AGENDA
BOARD OF PUBLIC WORKS MEETING
Tuesday, April 26, 2022 at 6:00 p.m.
Jackson Municipal Complex
Village Board Room
N168W19851 Main Street
Jackson, WI 53037

PROJECT:
MAPLE FIELDS - PHASE 1
SINGLE FAMILY RESIDENTIAL SUBDIVISION
VILLAGE OF JACKSON, WISCONSIN
BY: NEUMANN DEVELOPMENTS, INC.
N27W24025 PAUL COURT, SUITE 100
PEWAUKEE, WI 53072

16016

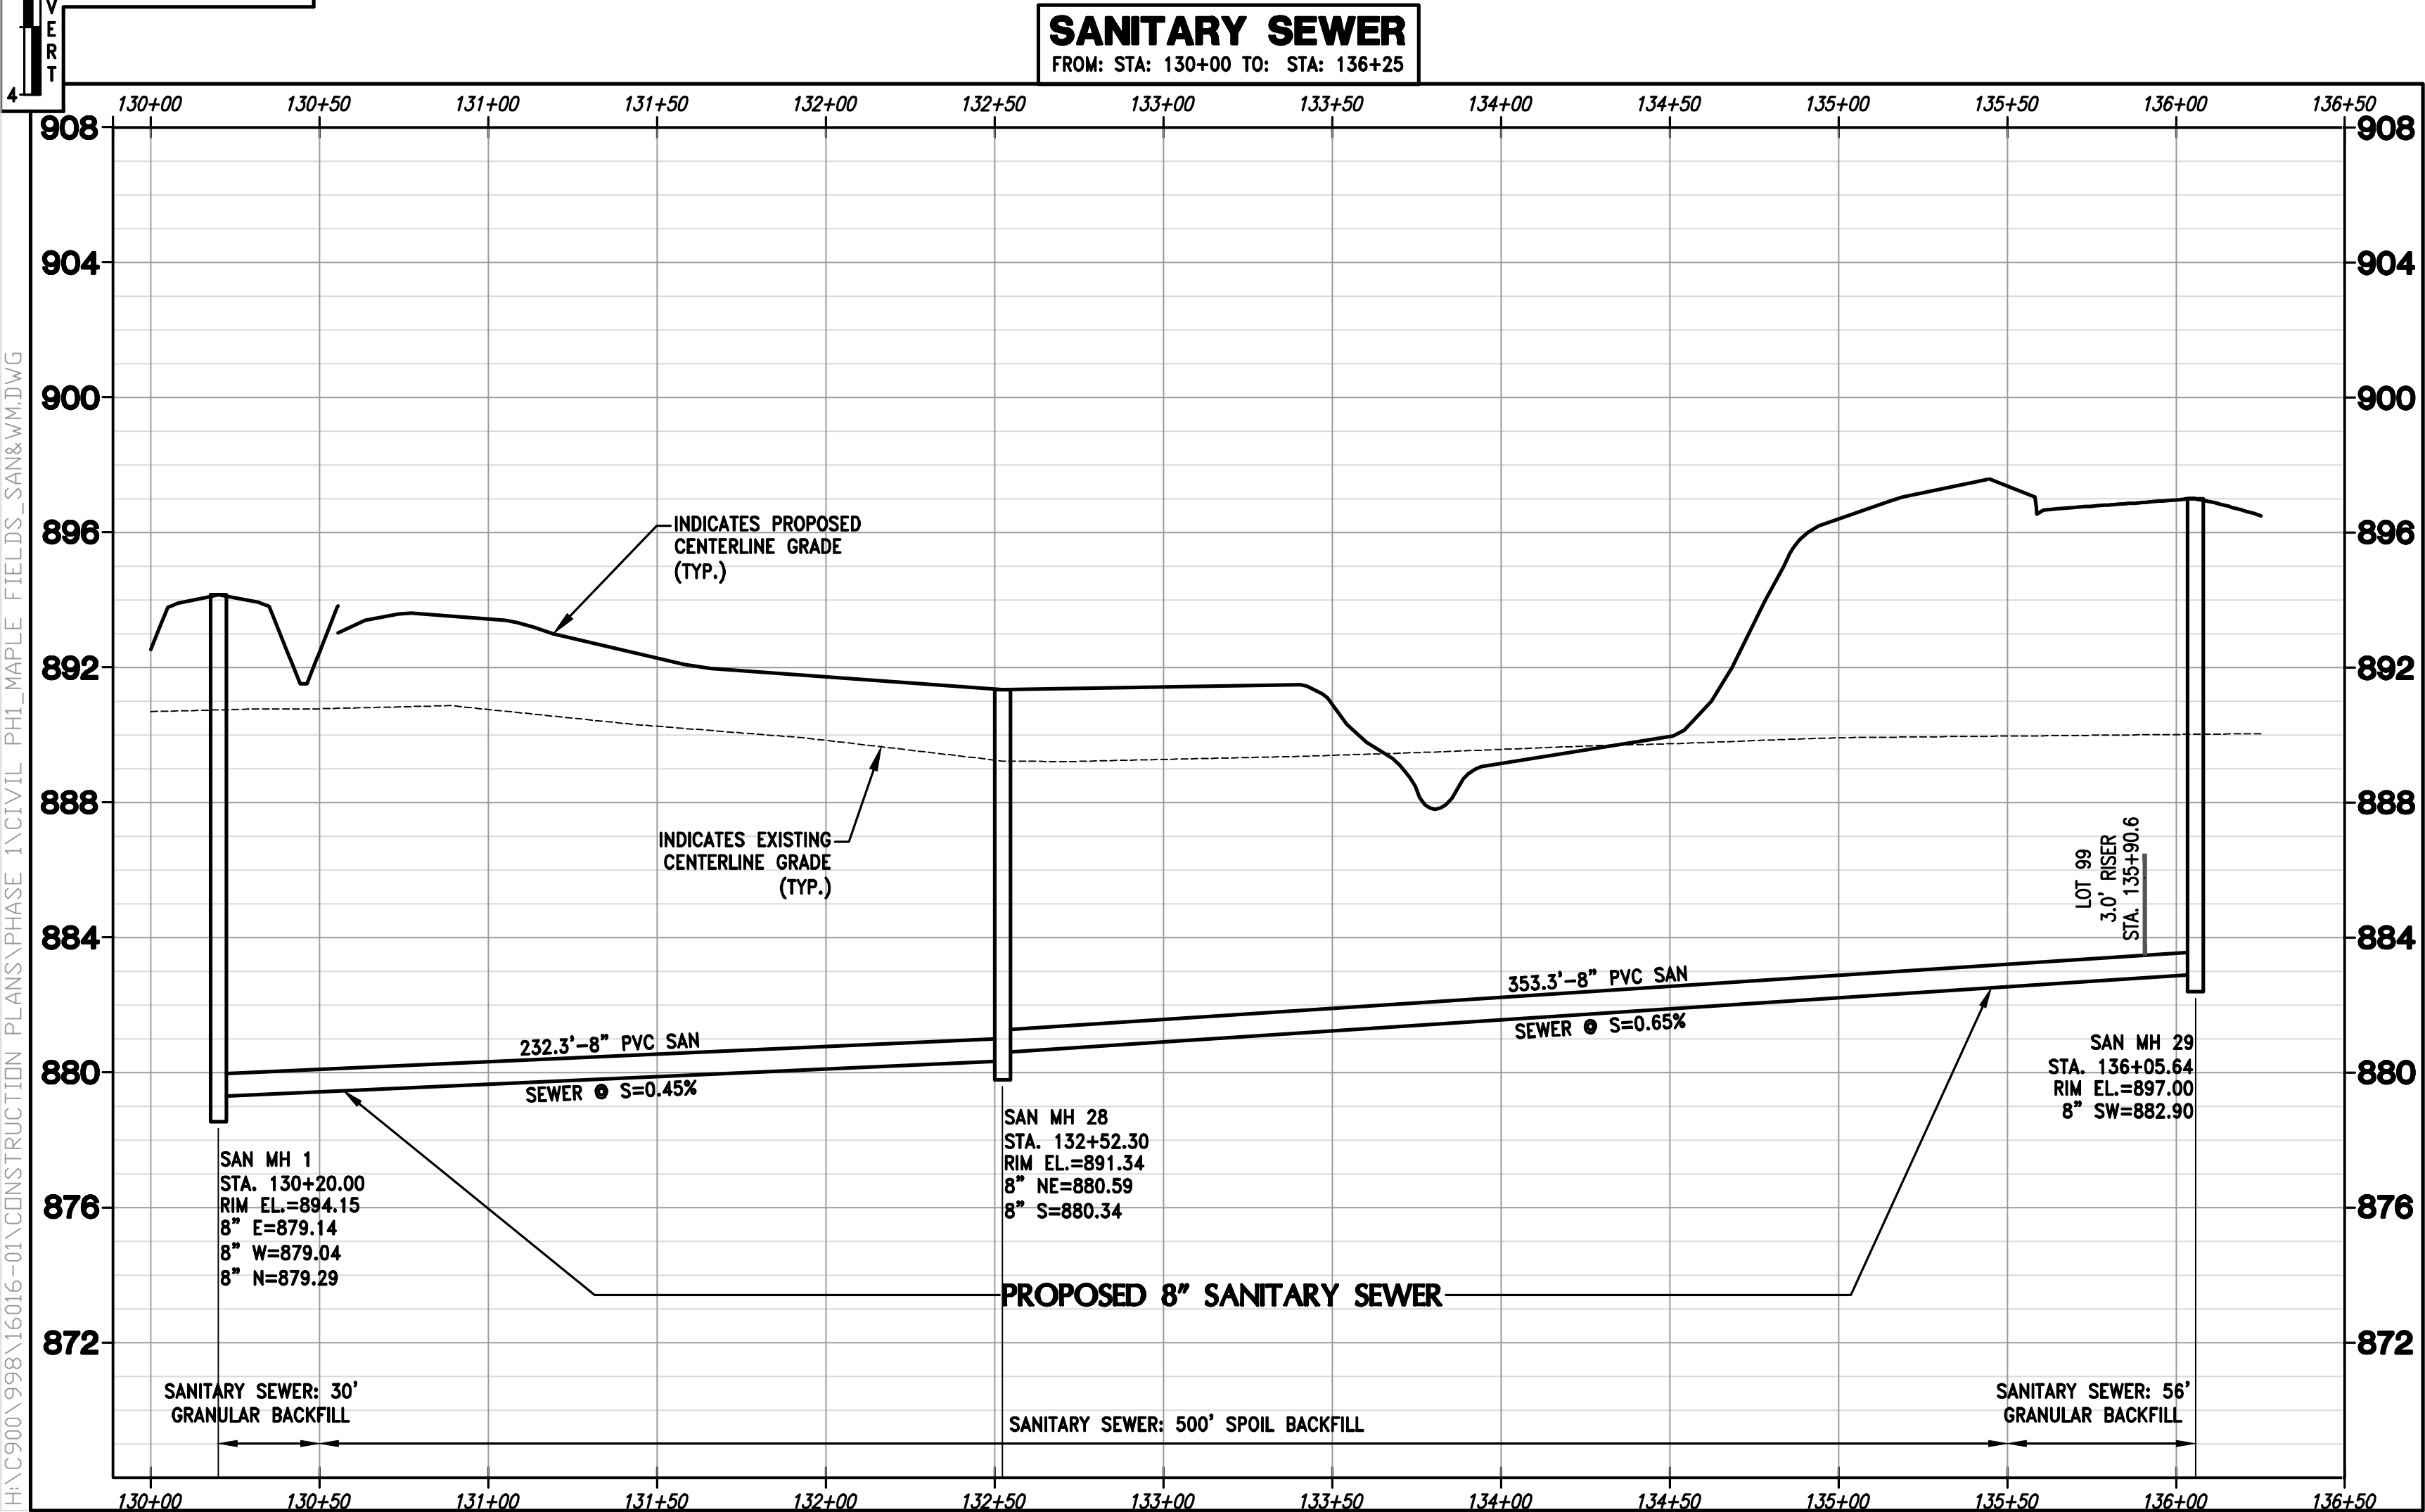
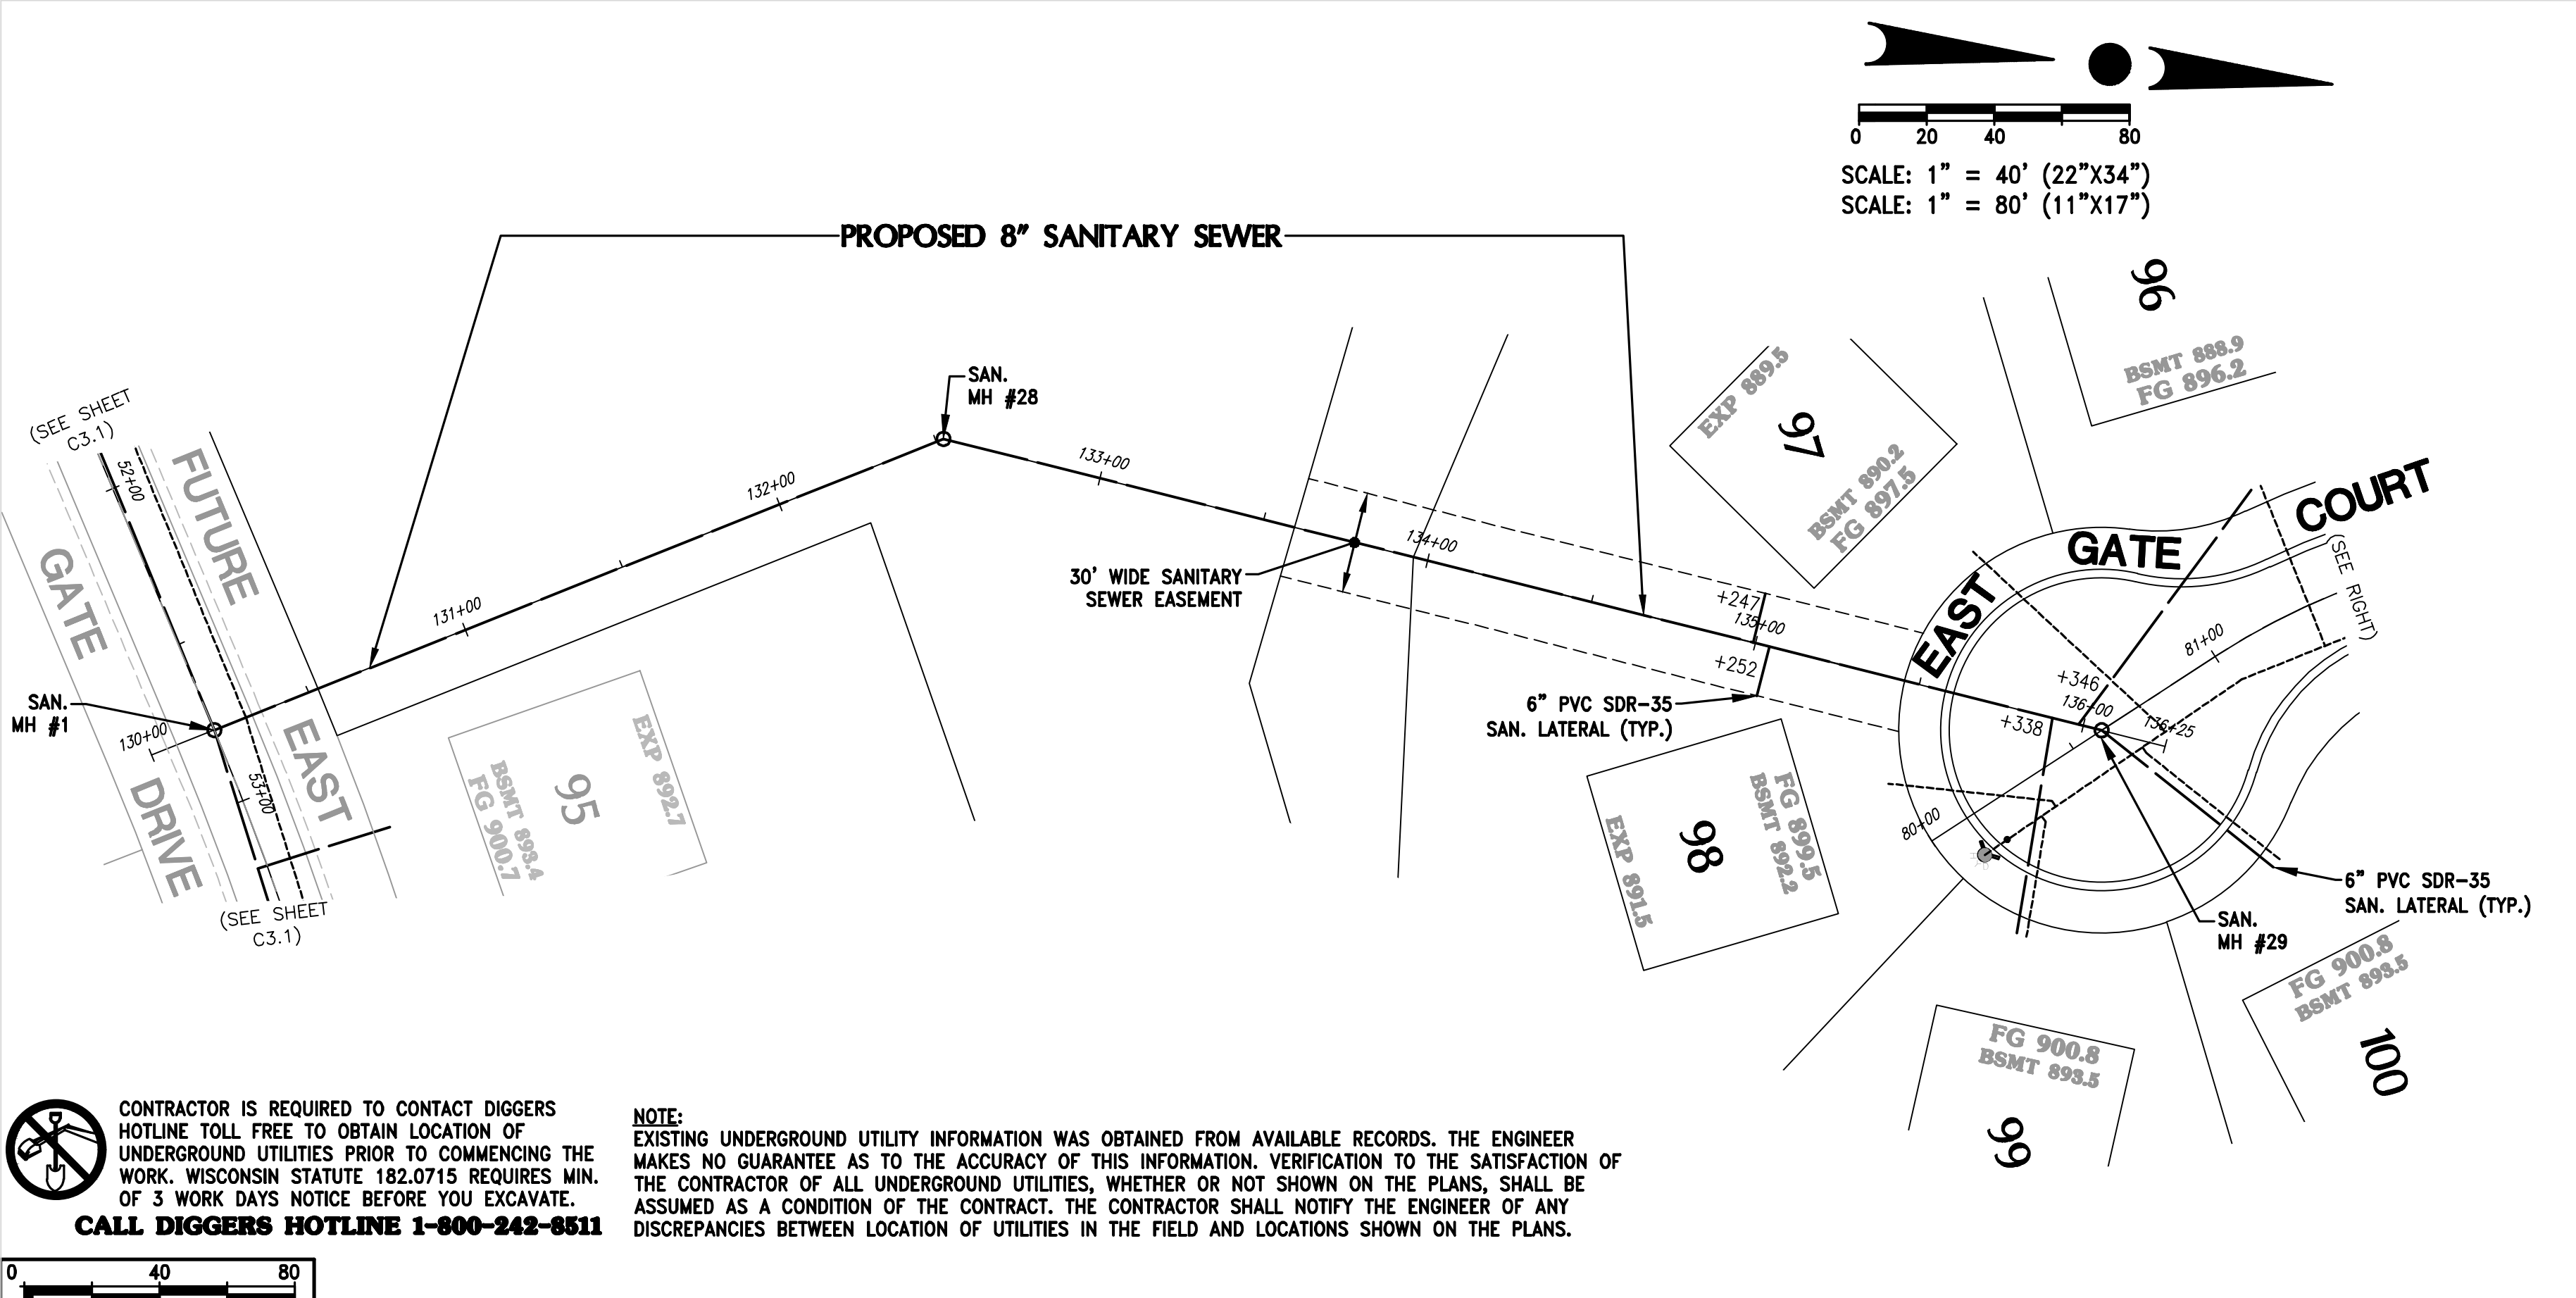
- 16) Sheet Number C3.6 A drivable area over the 8-inch sanitary sewer main serving East Gate Court. Please see culvert comment with sheet number C3.0. A 30 ft easement will need to be continued in Outlot or per the Development Agreement the Jackson Sewer Utility is allowed access in outlot.

- 17) Sheet Number C3.6 No sanitary sewer laterals are allowed to discharge directly into a sanitary sewer manhole.
- 18) Sheet Number C3.6 Reusing existing hydrant shall be inspected by the Jackson Water Utility before reinstallation. No hydrant extensions will be allowed to get to proper height.

MANHOLE NOTE

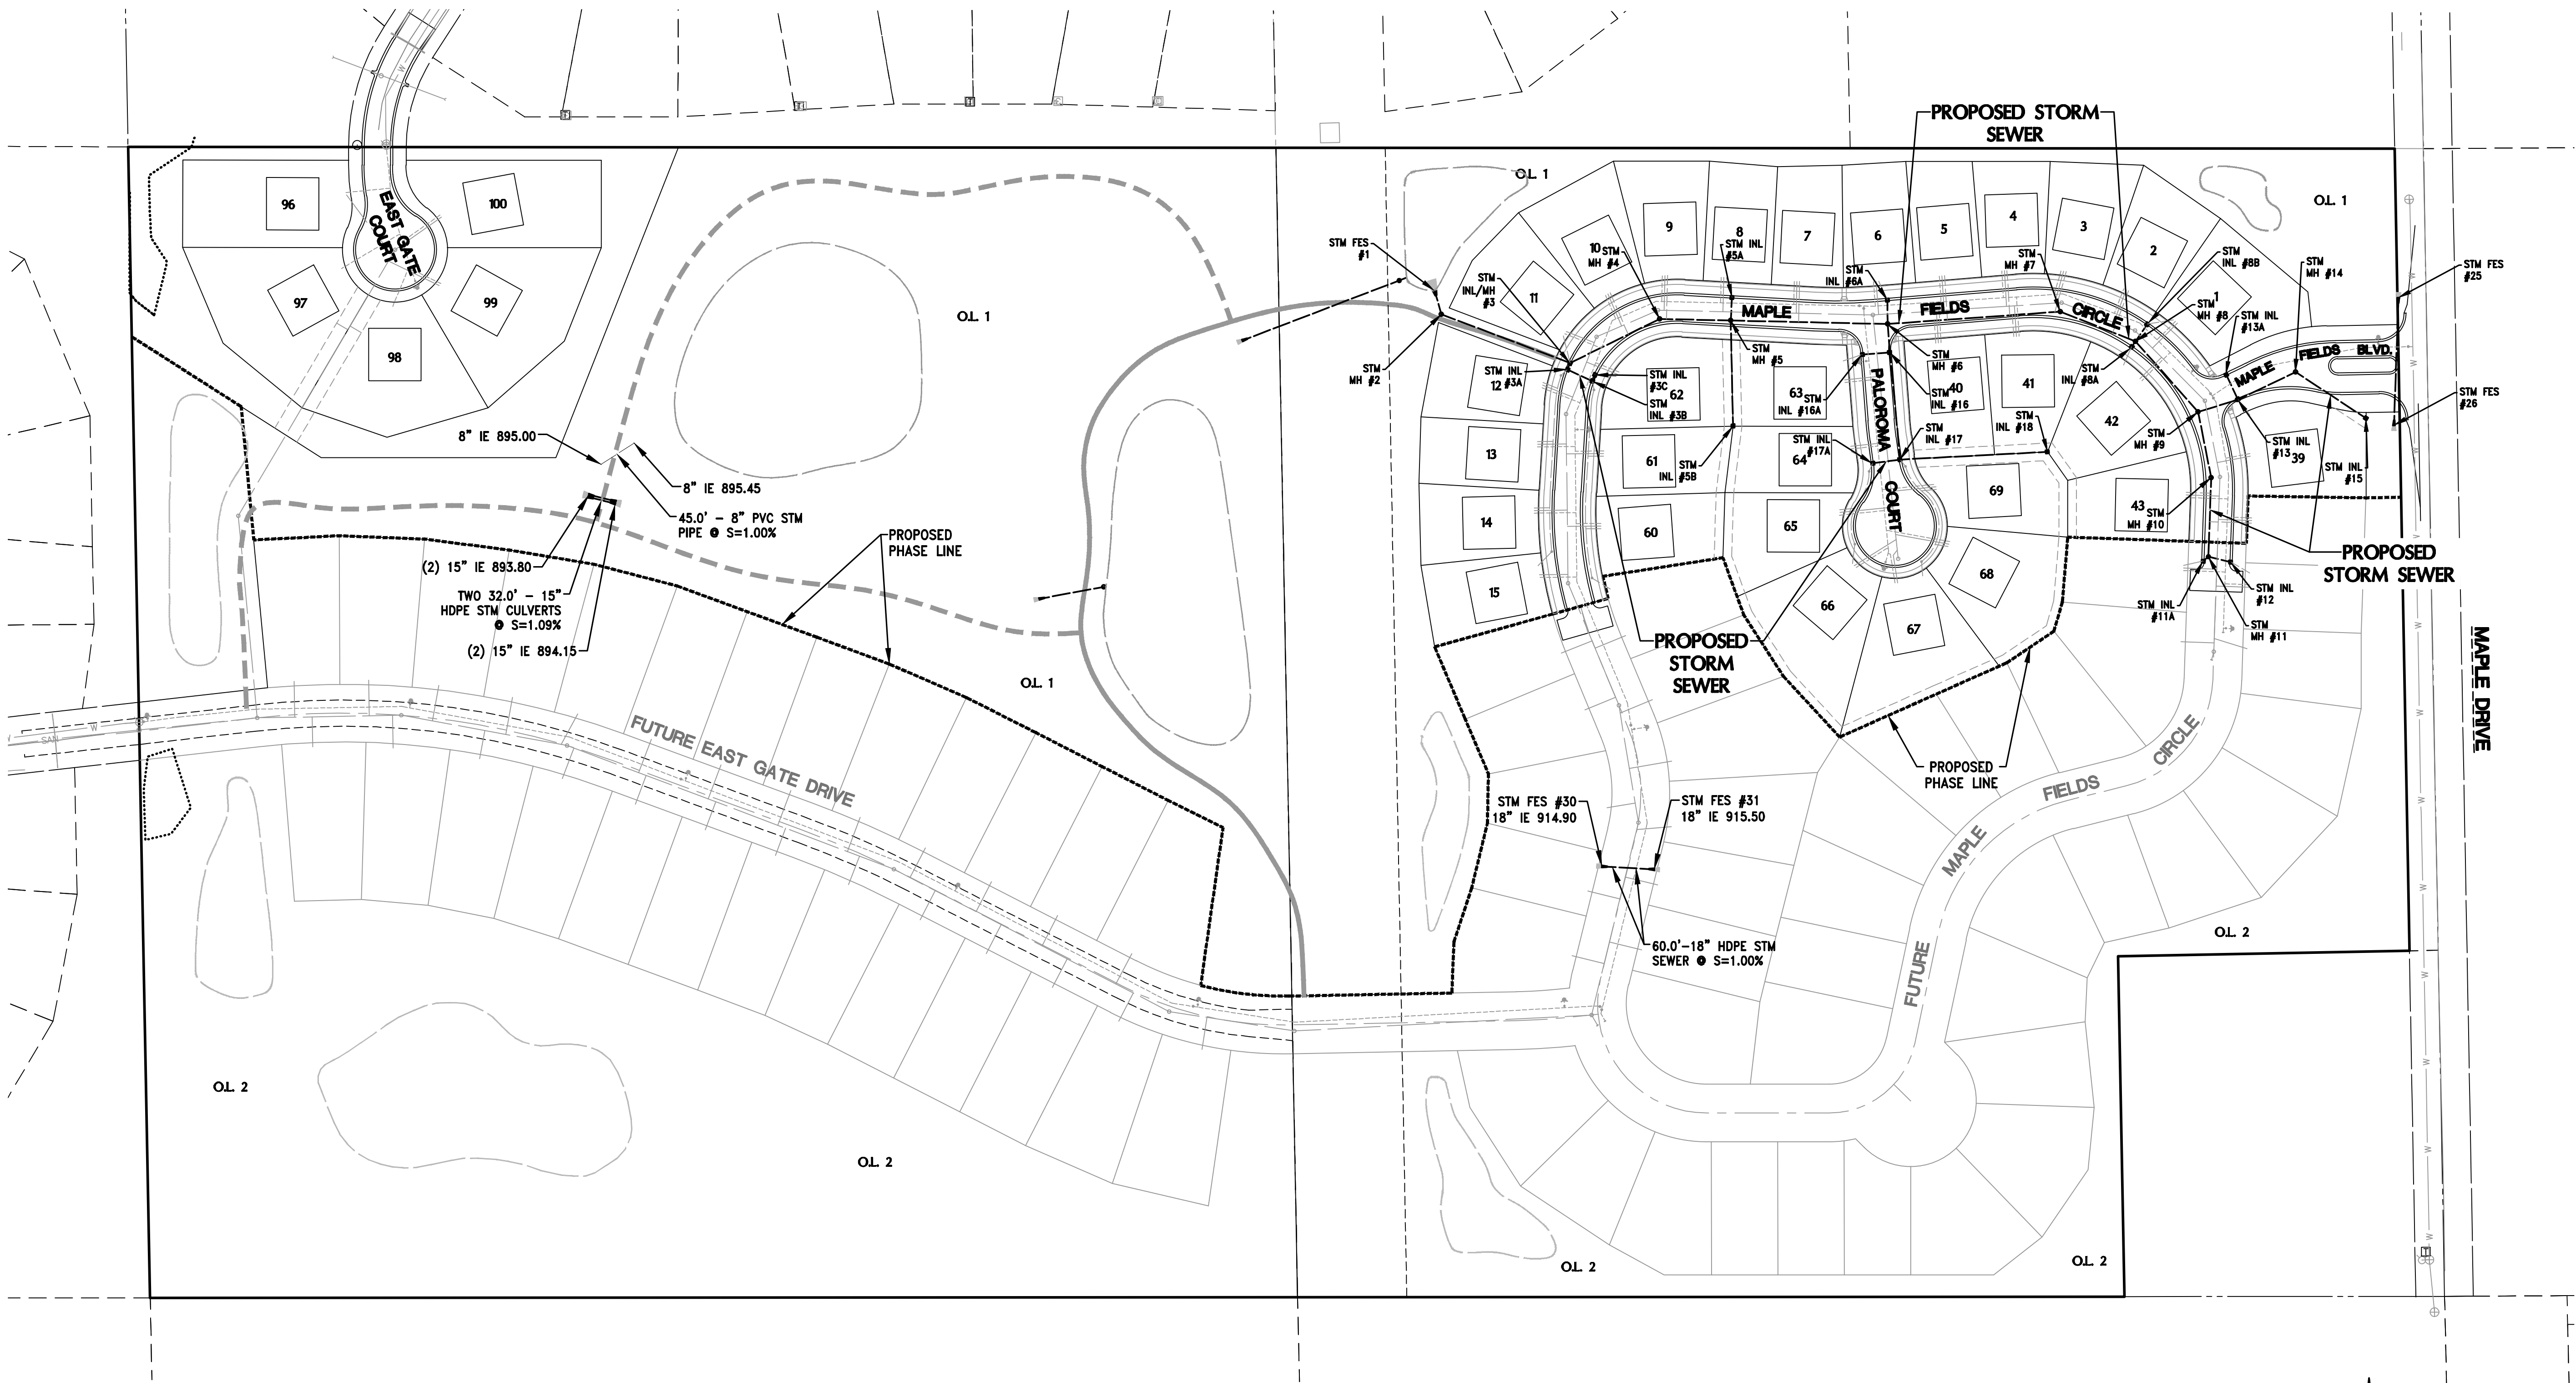
- 1) Sheet Number C3.0 Change Manhole and valve note to read: "Manhole castings to be set to final grade and gate valves can be set to binder grade."
- 2) Sheet Number C3.0 In Backfill Notes, change Village of Summit to the Village of Jackson.

- 3) Sheet Number C3.0 A culvert for ditch is needed by manhole #1 to access sanitary serving East Gate Court.
- 4) Sheet Number C3.1 At Station 51+45 the existing hydrant has been removed and a cap has been installed. Plan set should state remove cap & install new 8-inch gate valve.
